Department of Transportation
Technical Services
Roadway Engineering Section
355 Capitol Street NE, Room 222
Salem, OR 97301-3871
Telephone 503-986-3714
FAX 503-986-3749

Addenda No. 2

SUBJECT: Bay Blvd Sidewalk, Lights, & Paving (Newport) Section
SW Bay Boulevard
Lincoln County
(Bids to be opened and read July 16, 2009)

SHEET NO. 7 **RIGHT-OF-WAY AND ALIGNMENT**

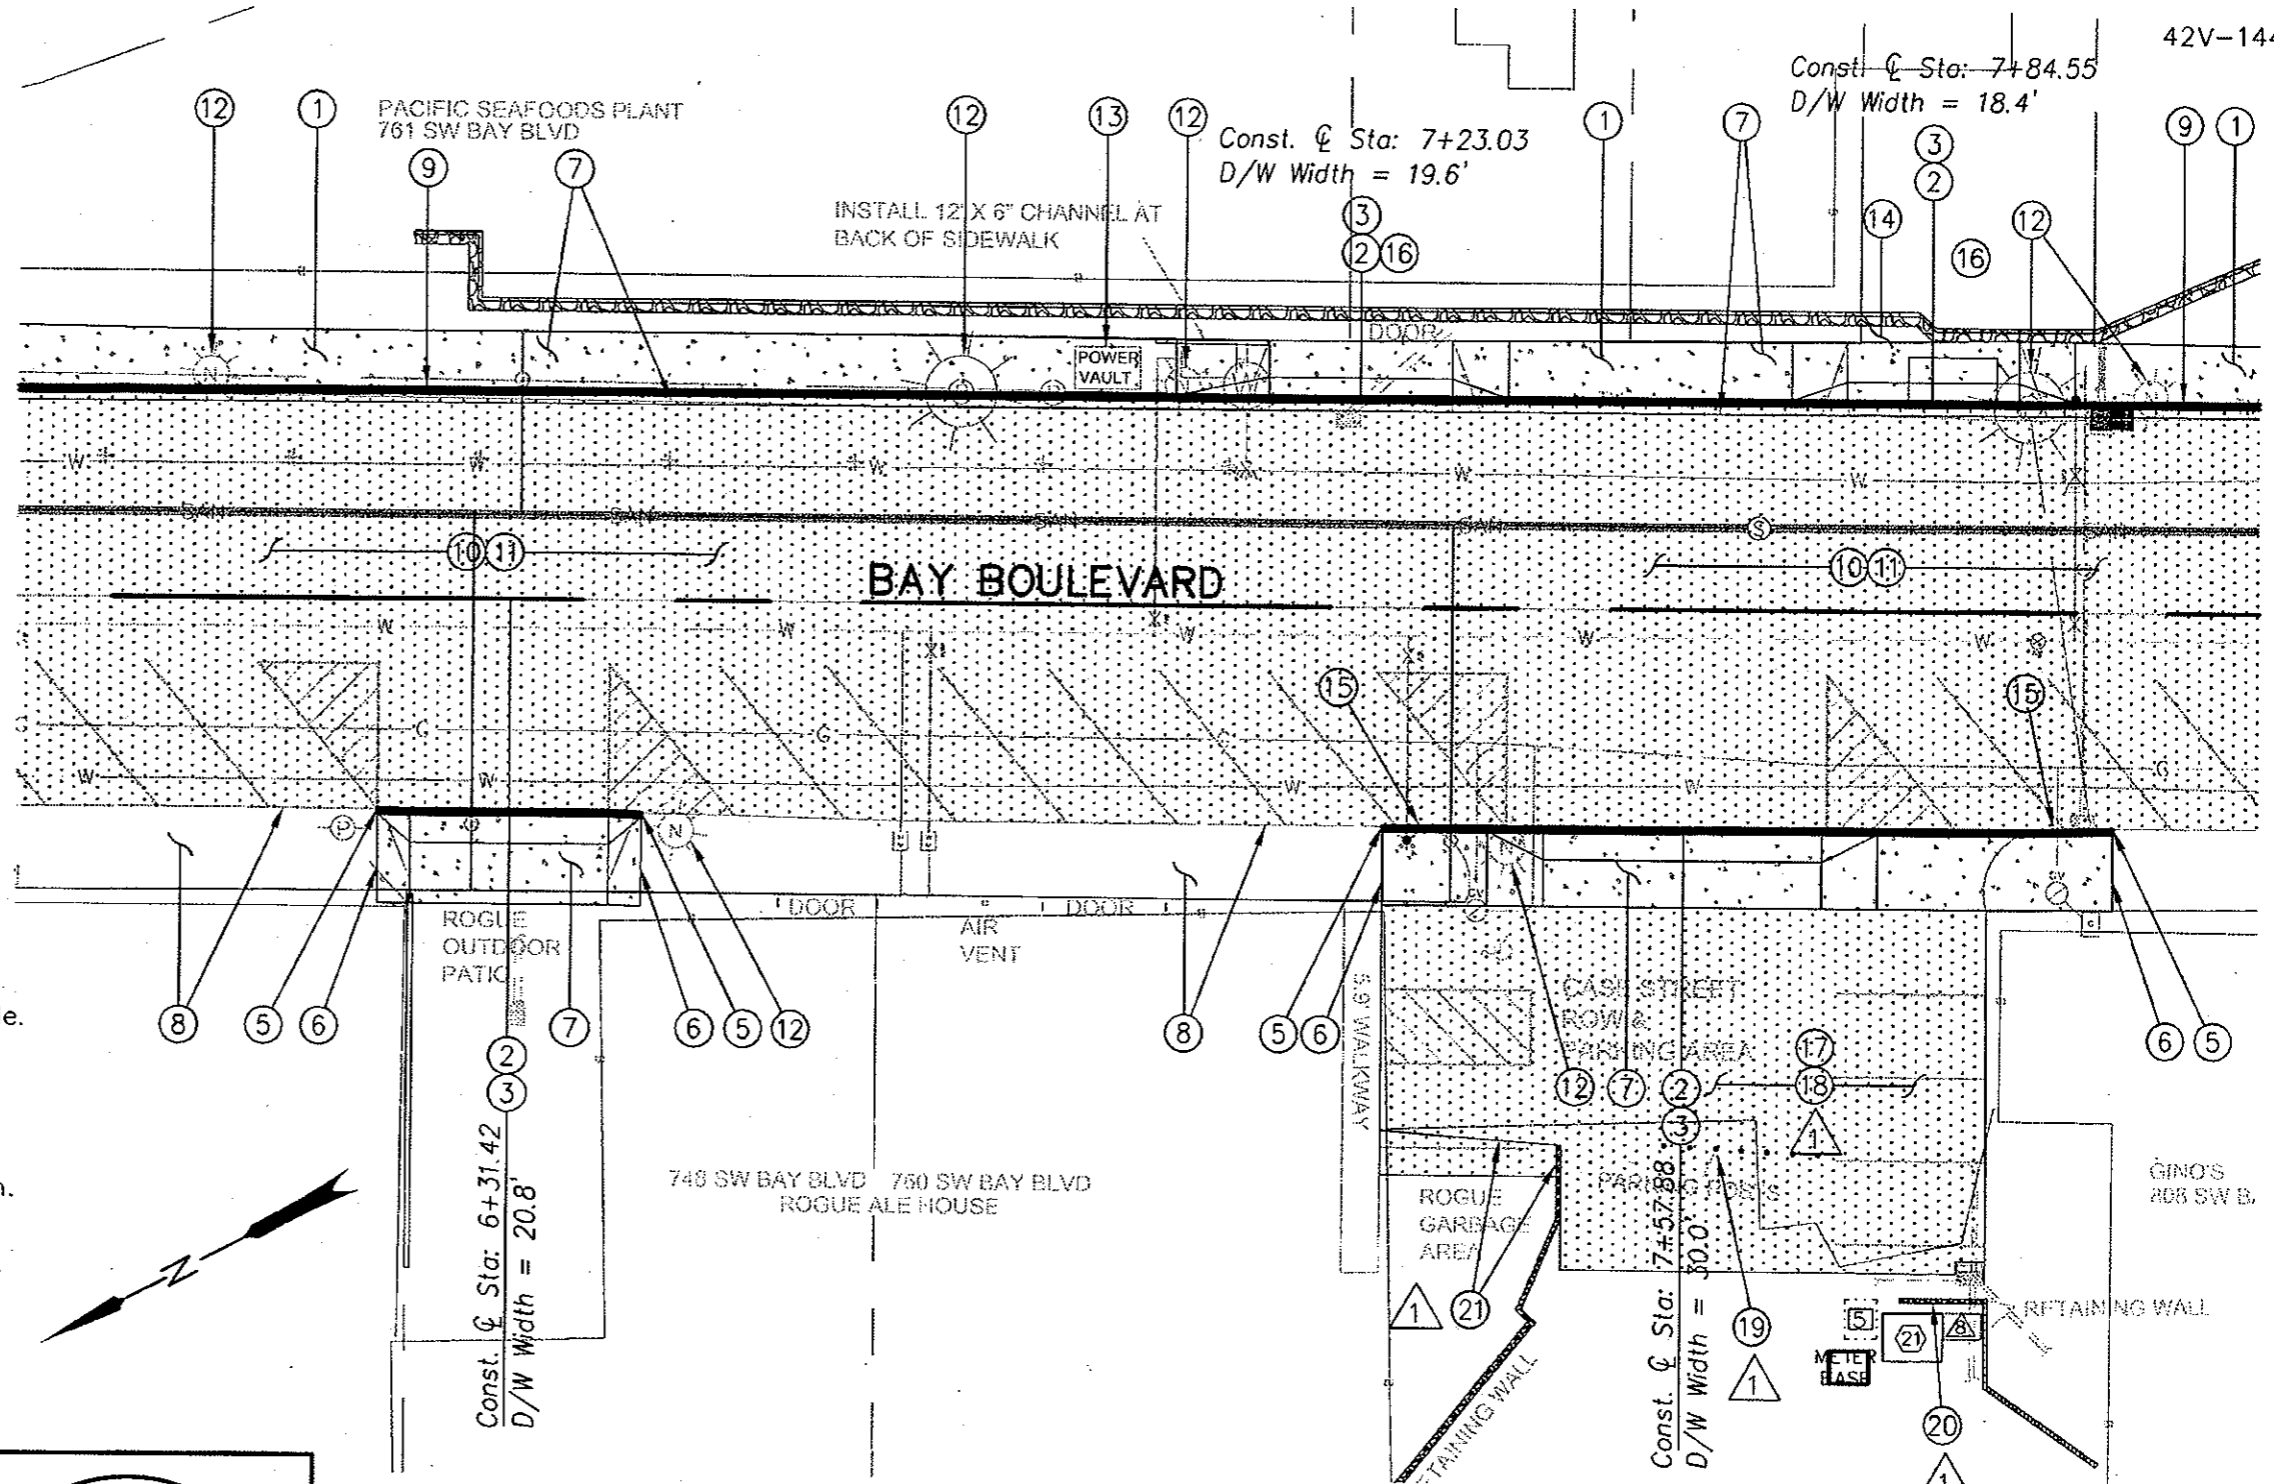
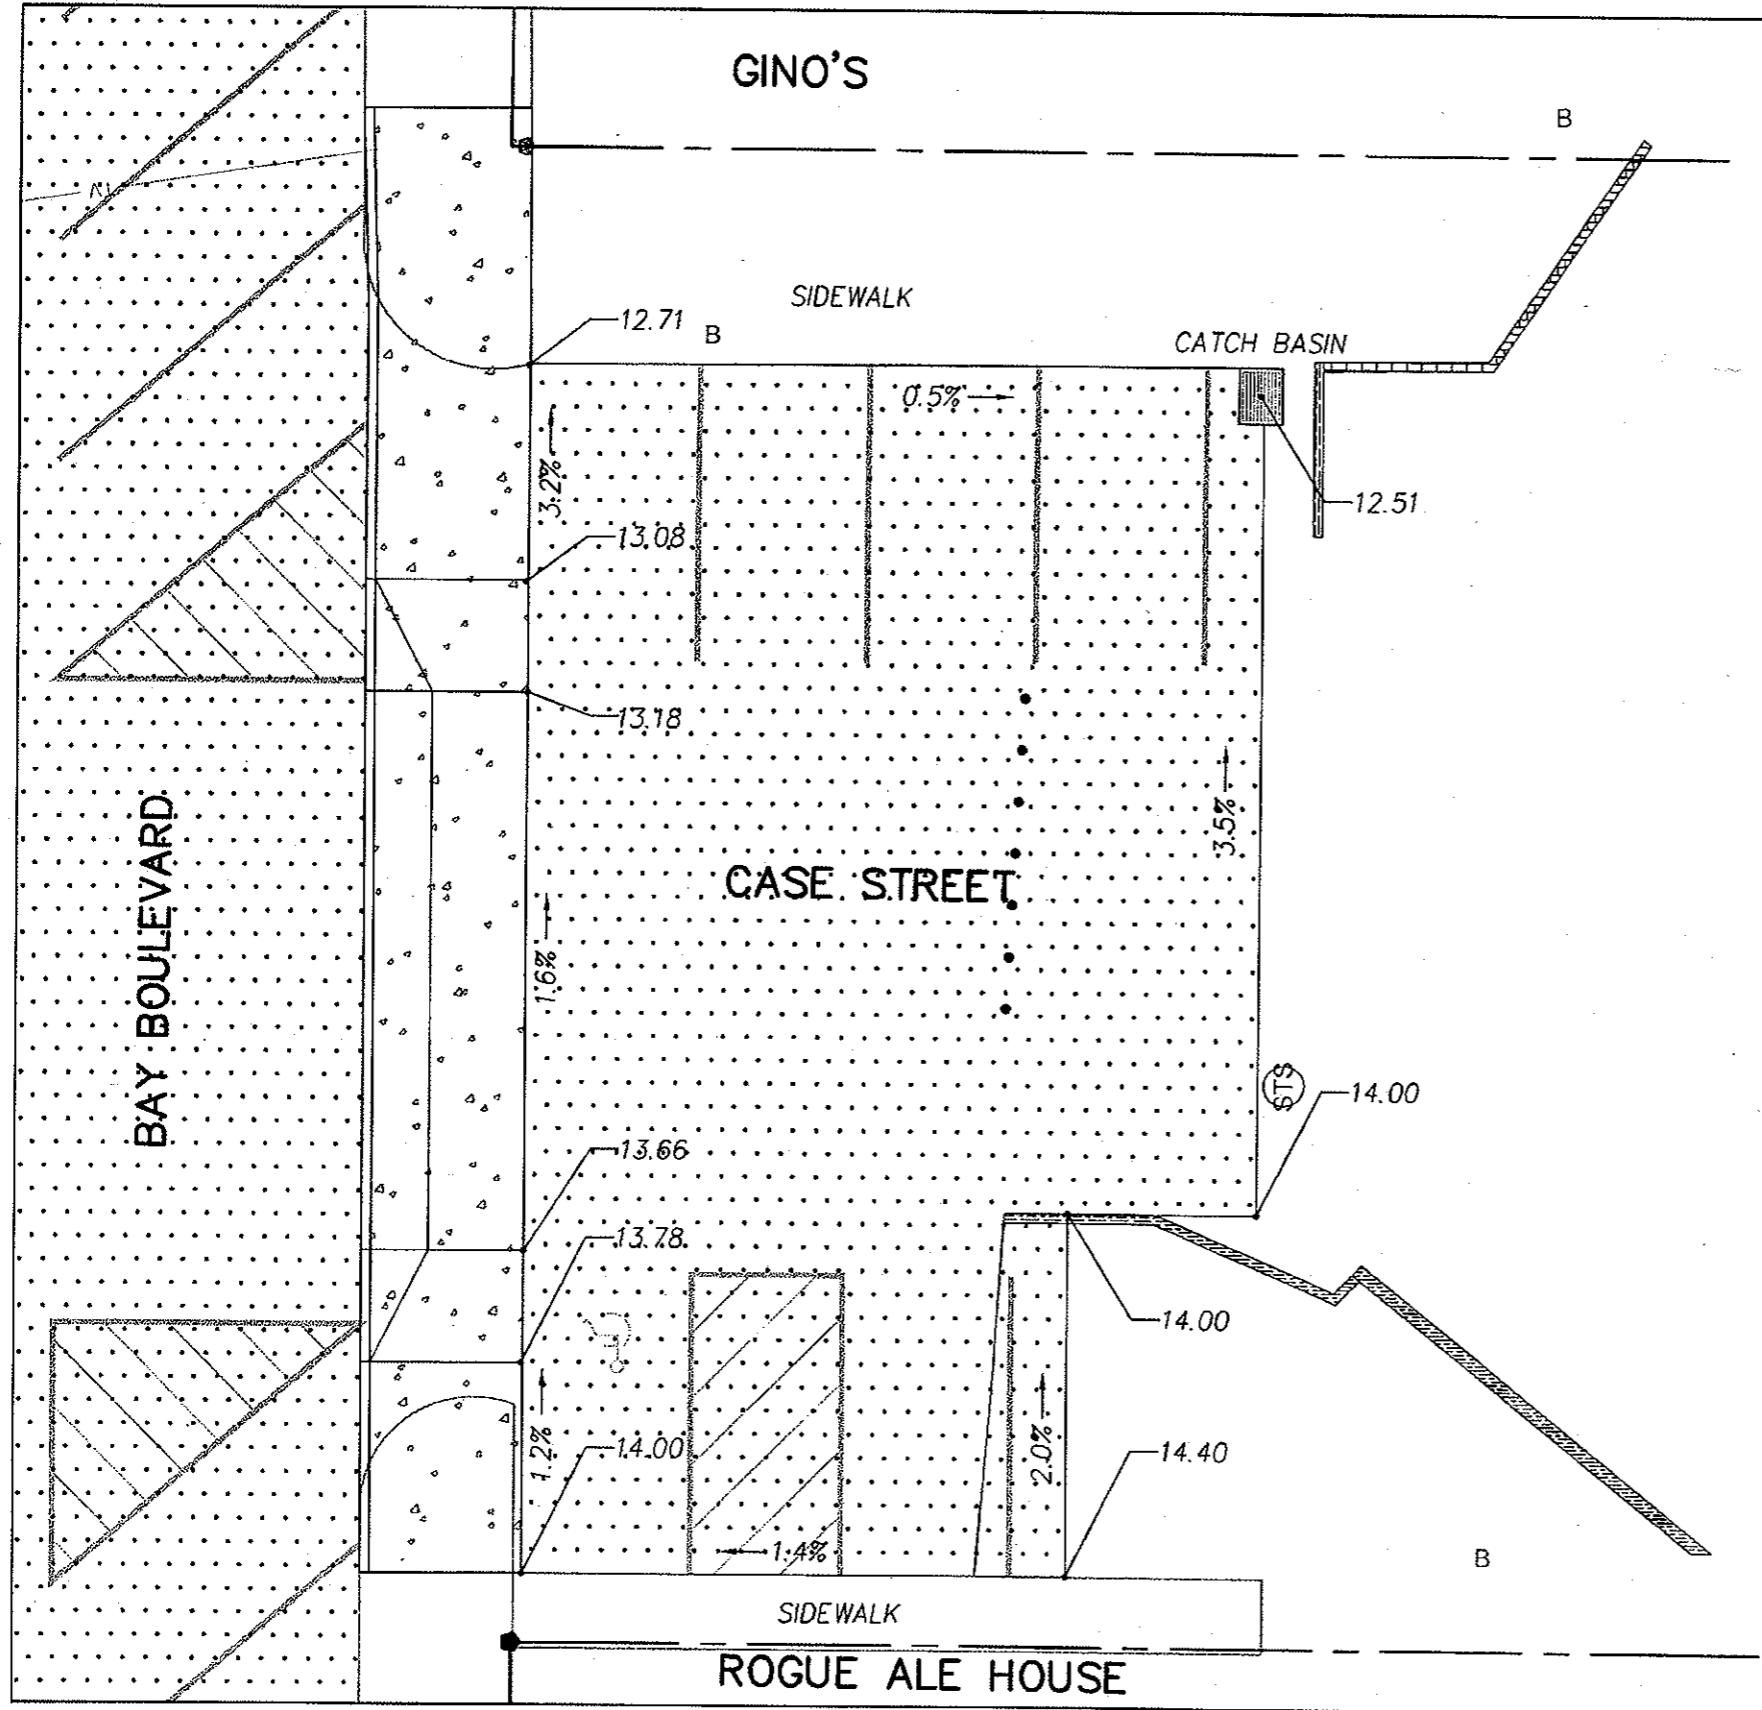
- ⑯ Match Existing Driveway At Back Of Apron.
- ⑰ Construct Parking Lot Widening With 3" of 1/2" Dense, Level 2 HMAC on 8" of Compacted 3/4" (Minus) Rock. Refer To Sheet 2B-38 For Detail.

REVISIONS	
①	REVISED 7-8-2009 ADD NOTES 17, 18, 19, 20 & 21. DELETE NOTE 4
②

-  ⑱ Remove Existing Asphalt Surfacing
-  ⑲ Remove Bollards
-  ⑳ Remove and Replace Wooden and Rockery Retaining Wall For Utility Vault Installation
-  ㉑ Screen Wall and Concrete Pad to Be Removed By Others Prior To Construction
